Kentucky Power Company  
KPSC Case No. 2019-00443  
Commission Staff's First Set of Data Requests  
Order Dated April 28, 2020

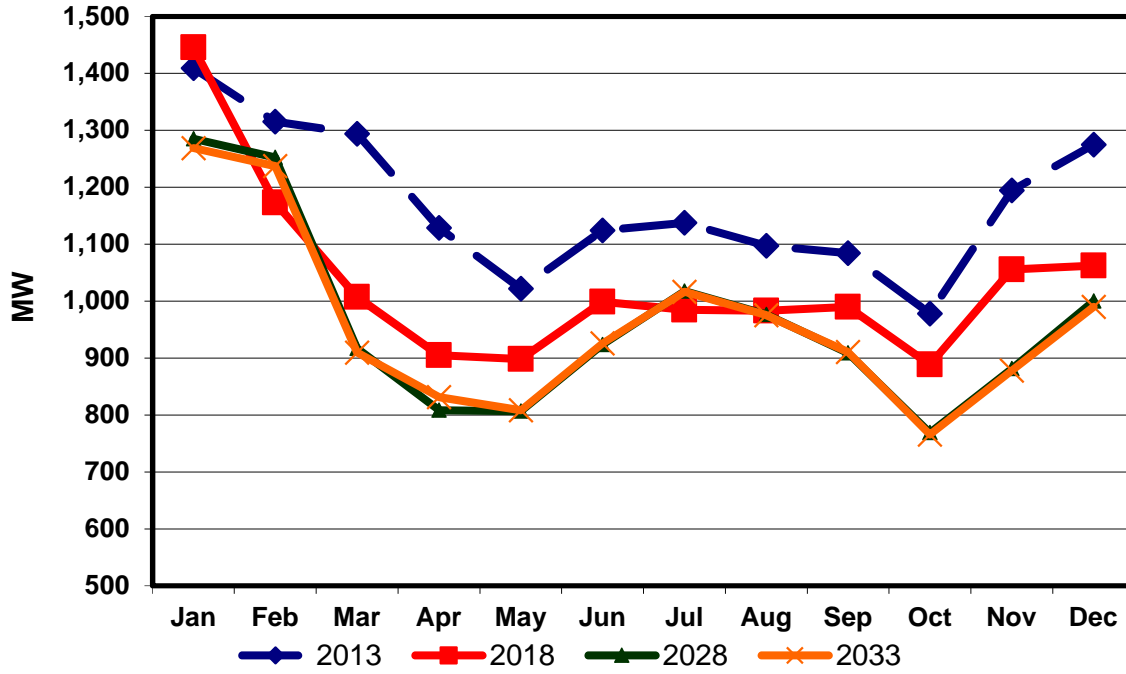
**KPSC 1\_65** Refer to the IRP, Appendix C-19. Provide the labels for the graph.
